REQUEST FOR INFORMATION **DATE:** August 29, 2016 **NO.:** RFI-258

Project Name: 15051-Webster University Interdisciplinary Science Building Project No.: 15051

Subject: Backfill Details

DETAIL-1A:
TYPICAL DETAIL AT ENTIRE
LEVEL 01.

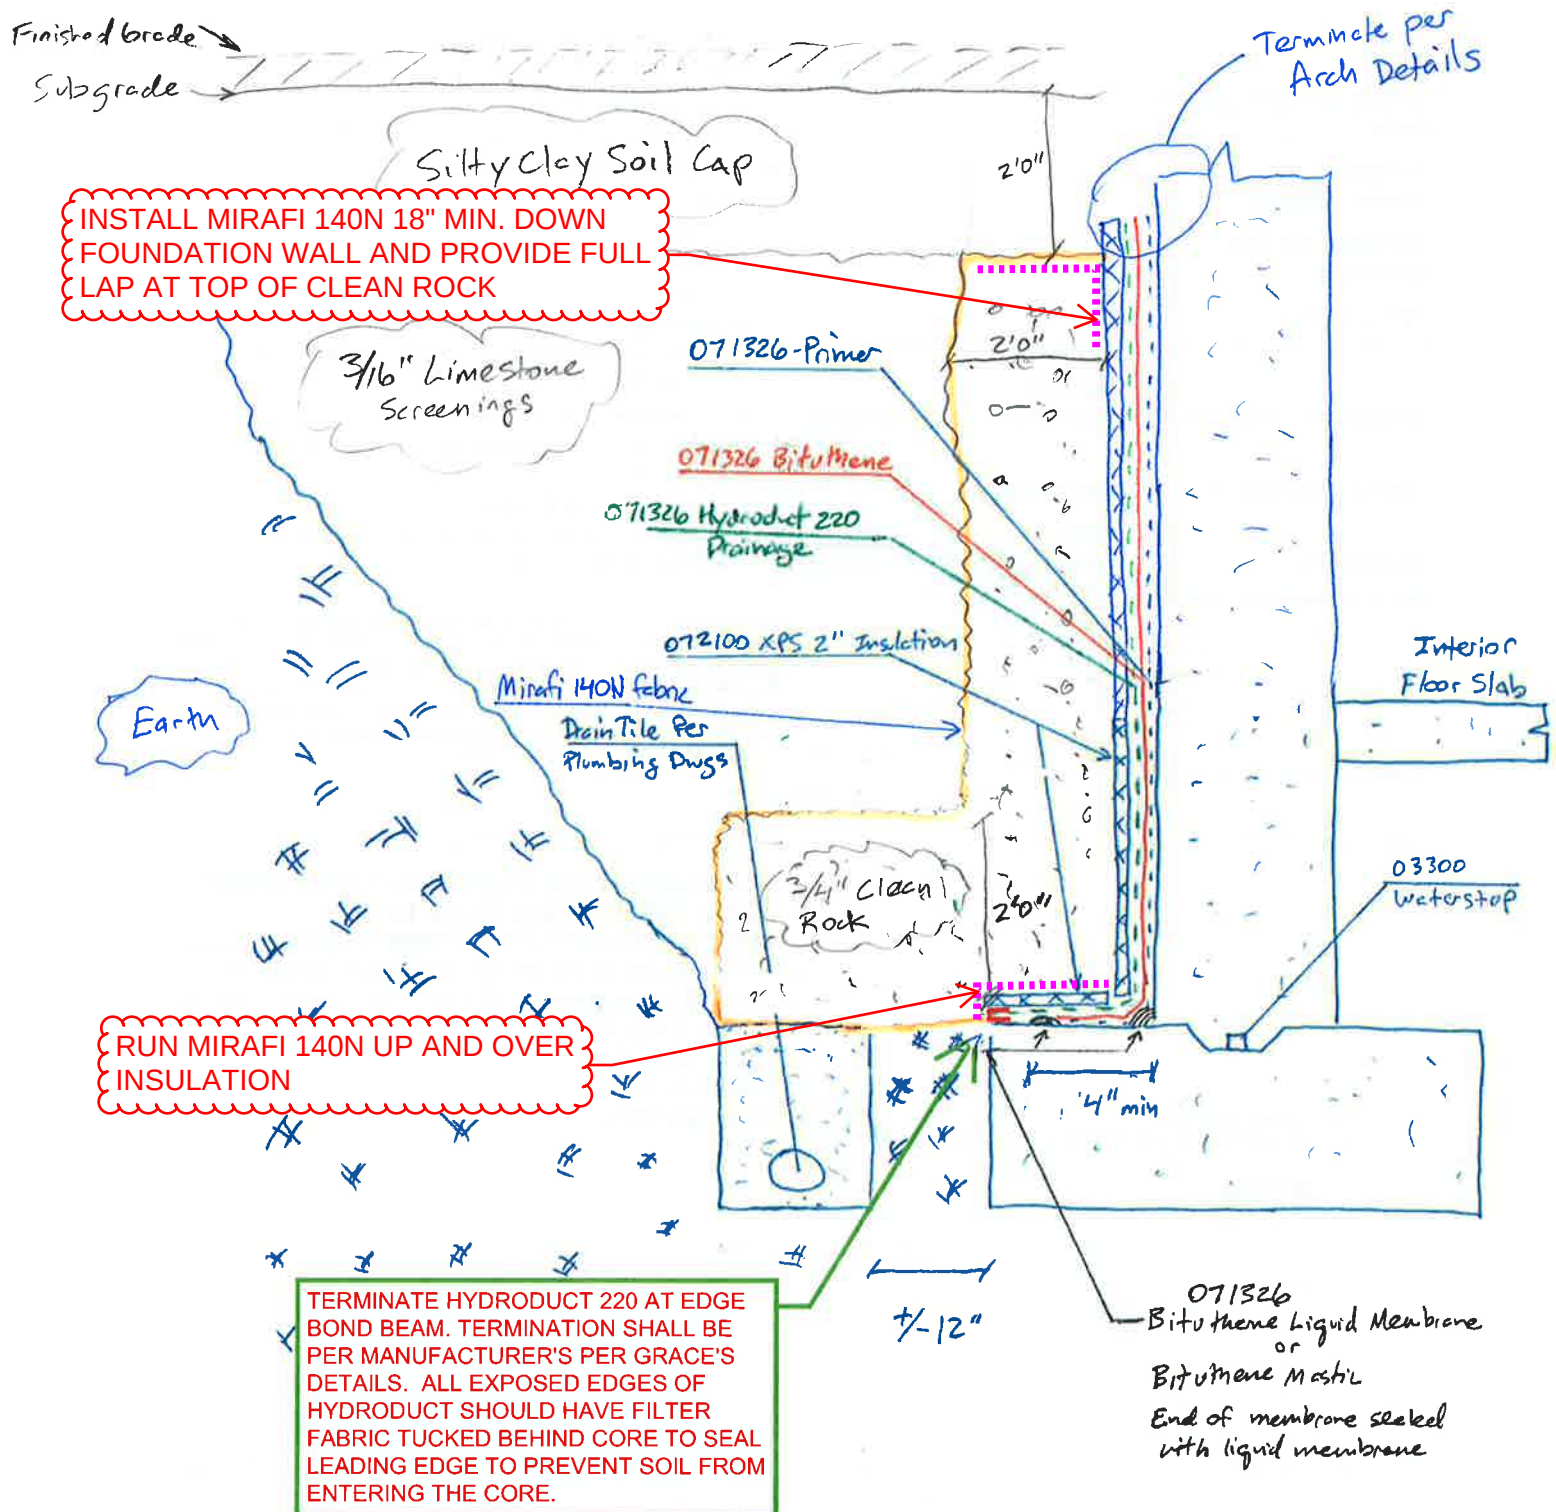
Please confirm if the attached backfill details are accurate based on conference calls held on Friday 8/26/16 with Akins, DMA, Cannon and Paric. Please note the interior backfill detail will only be utilized on the foundation walls at L-0 that fall within the L-1 slab on grade area (highlighted in yellow). All other walls on L-0 and L-1 will follow the backfill exterior foundation wall detail. Also, please advise of a waterproofing termination detail at the top of the interior walls as circled on the attached sketch.

AT-REST PRESSURES FOR THE DESIGN OF THE TEMPORARY SHORING OF WALLS SHALL BE AS FOLLOWS:
AT-REST PRESSURE = 74 PCF AT EXISTING 3/16" SCREENINGS – EXTENDS UP TO APPROX 4'-0" ABOVE ELEV 72'-0", OR 76'
AT-REST PRESSURE = 63 PCF AT LIMITED ¾" CLEAN GRANULAR BACKFILL – PROVIDED FROM APPROX 76' TO 86'
WHERE THE ENTIRE WALL IS BACKED WITH A COLUMN OF ¾" CLEAN GRANULAR BACKFILL, AT-REST PRESSURE = 63 PCF FOR FULL HEIGHT
THESE PRESSURES ARE BASED ON THE BACKFILL AND DRAINAGE SYSTEM AS DETAILED ON THE ATTACHED SHEETS.

SEE MARKUPS ON THE ATTACHED BACKFILL DETAILS (REVISED PER CONFERENCE CALL ON TUESDAY 09/06/2016).
